V2500-D5 SERIES PROPULSION SYSTEM SERVICE BULLETIN

This document transmits Revision 2 to Service Bulletin NV2500-71-0232 and the Initial Issue of the Supplement

V2500-NAC-71-0232
Transmittal - Page 1 of 3

NACELLE – NOSE COWL – FORWARD BULKHEAD FITTING, THERMAL ANTI-ICE DUCT –
MODIFICATION OF

T.A.I. Access Panel Removal/Installation
Figure 1

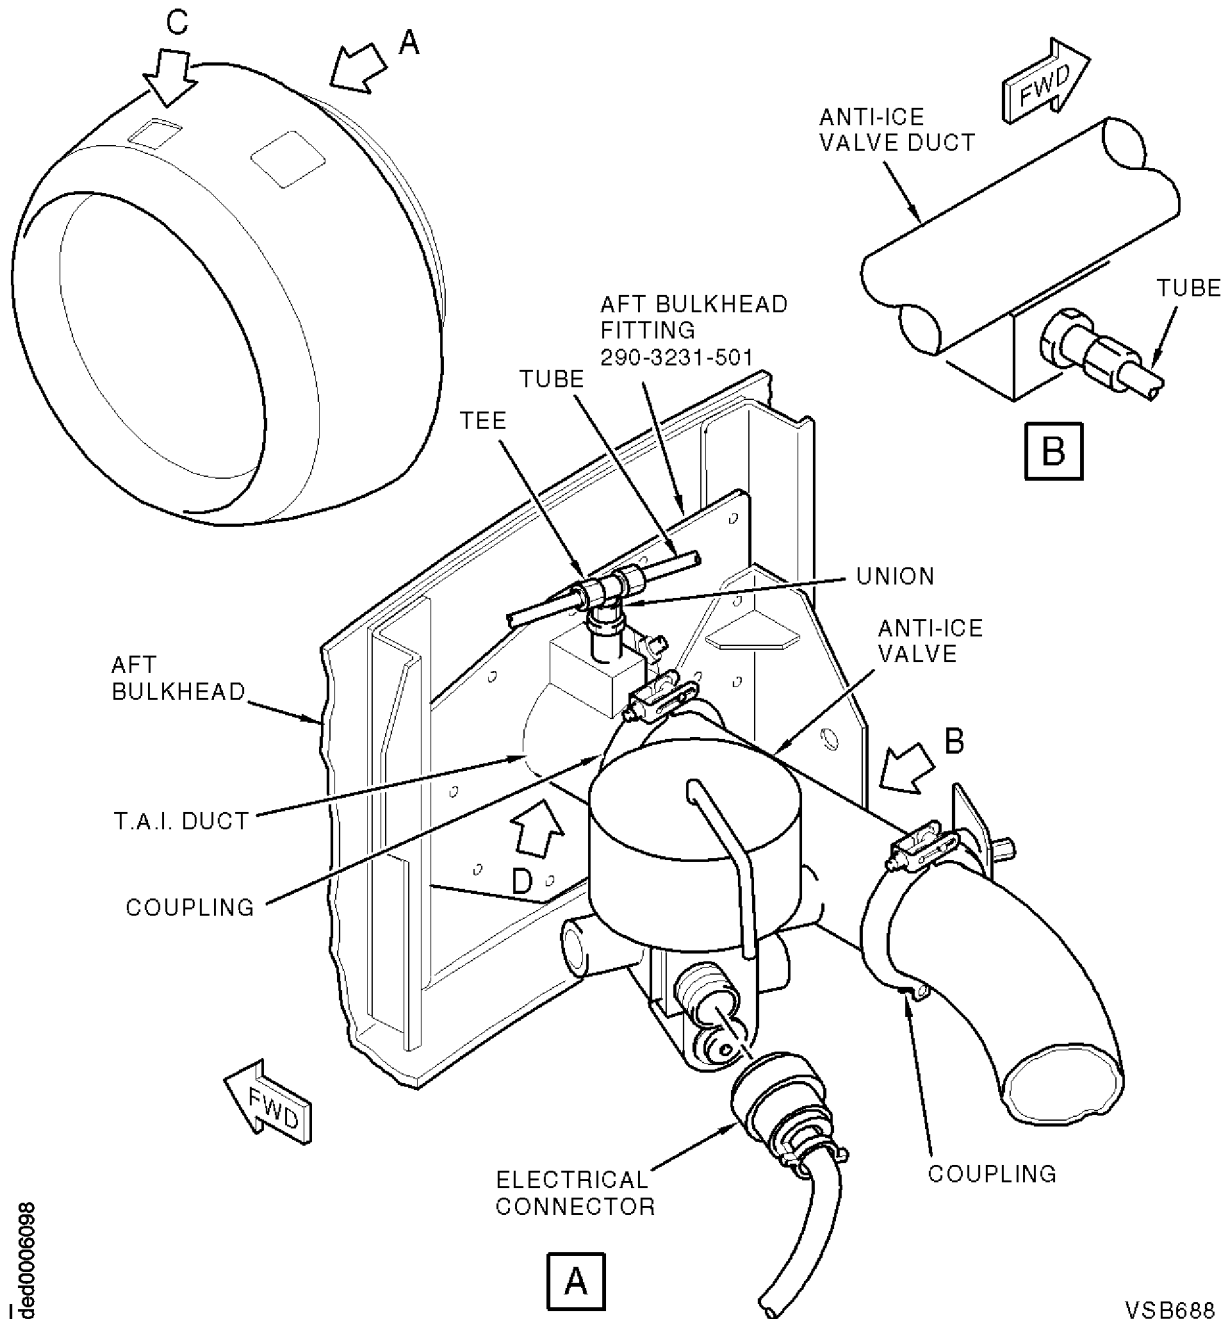
- (1) Remove the fifteen NAS720U45 bolts and the 290-3183-501 thermal anti-ice (T.A.I.) access panel from the nose cowl. Refer to Figure 1.
- (2) Open the fan cowl doors. Refer to the MD-90 Aircraft Maintenance Manual, Chapter 71-11-11, page block 201.

- (1) Install the T.A.I. access cover and fifteen NAS7204U5 attach bolts. Wet install the bolts with jointing compound (CoMat 04-005). Torque the bolts to 20-25 lbfin (2.62-2.82 Nm).
- (2) Close the fan cowl doors. Refer to the MD-90 Aircraft Maintenance Manual, Chapter 71-11-01, page block 201.

T.A.I. Duct Fitting Modification (if anti-rotation pin is present and firmly installed)
Figure 4

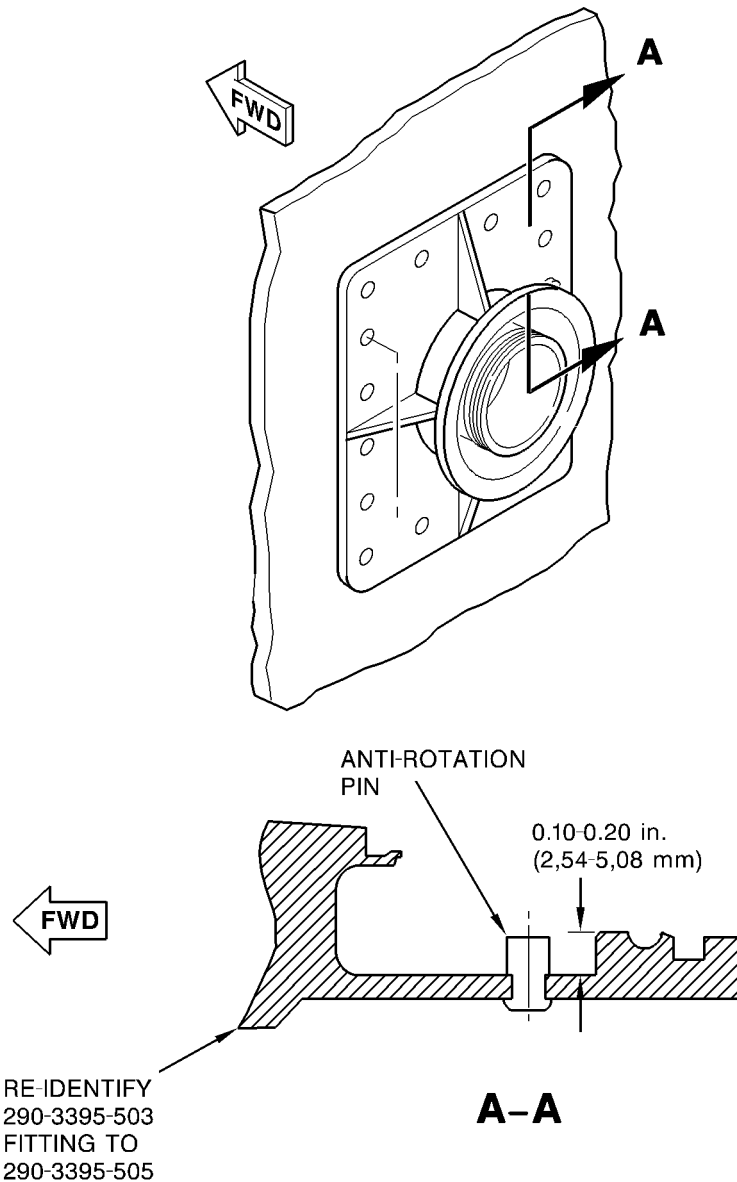
E. Modify the Forward Bulkhead Fitting (if the anti-rotation pin is present and firmly installed)

- (1) Cut the anti-rotation pin as shown in Figure 4.
- (2) Re-identify the 290-3395-503 bulkhead fitting as 290-3395-505. Use a rubber stamp and black ink (CoMat 06-073). Refer to the IAE Standard Practices/Processes Manual, Chapter 70-09-00.
